ORIGINATION FORM

Proposed Revisions to a Standard Plans Index
(Please provide all information — Incomplete forms will be returned)

Index Number: 520-010
Sheet Number (s): All
Index Title: Median Opening Flume

REDEVELOPED INDEX

FLUME DETAIL

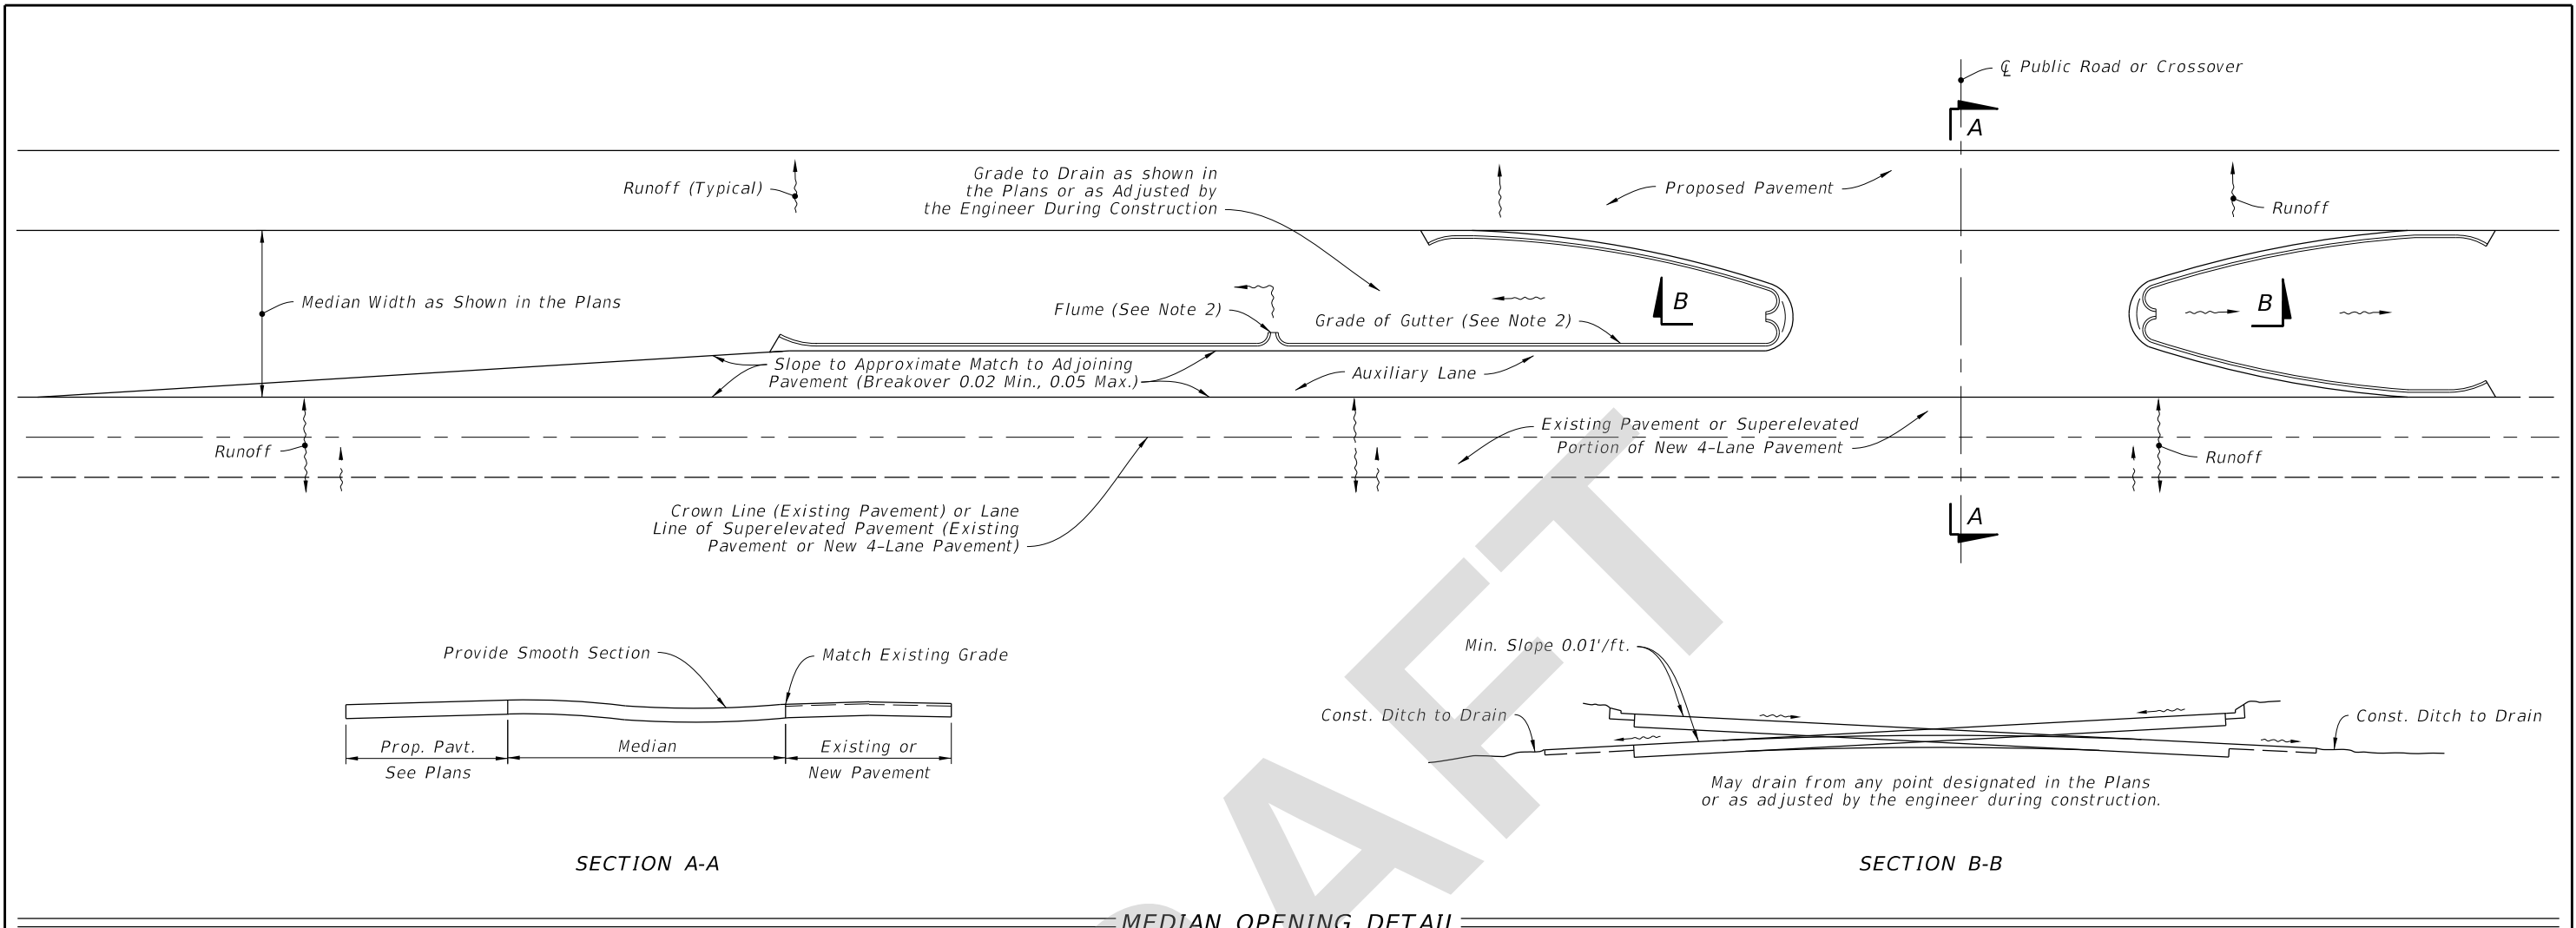
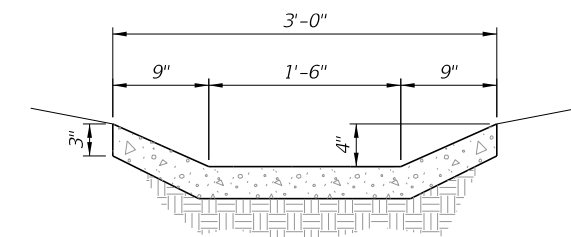
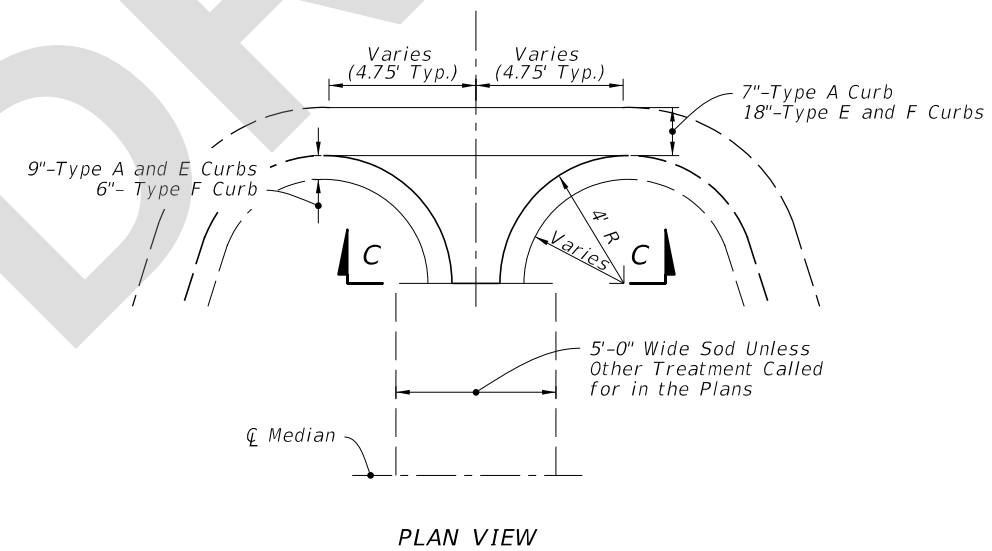
Redeveloped Index; Redrew details; Rewrote notes

Revised and reorganized details to match other indexes. Rewrote notes and deleted pay item and design information that is now located in the SPI.

Created new Note 2

~~Provide Approximately A Minimum Of 0.20% Grade On Gutter, Slightly Warping The Surface Of The Median Pavement If Necessary, Within Limits Of The Median Curb Or Curb And Gutter. Construct A Drainage Flume Or Flumes At The Point Or Points Of Low Grade. See Details.~~

1. These details are to apply to projects which provide for the conversion of 2-lane sections to 4-lane divided highway sections and for superelevated sections of new 4-lane divided highways. Layout above is illustration only.
2. See Plans for flume length and location and grade of gutter. Flume locations may be adjusted by the Engineer during construction. If necessary to provide minimum gutter grade, warp surface of the median pavement within limits of the median curb or curb and gutter.
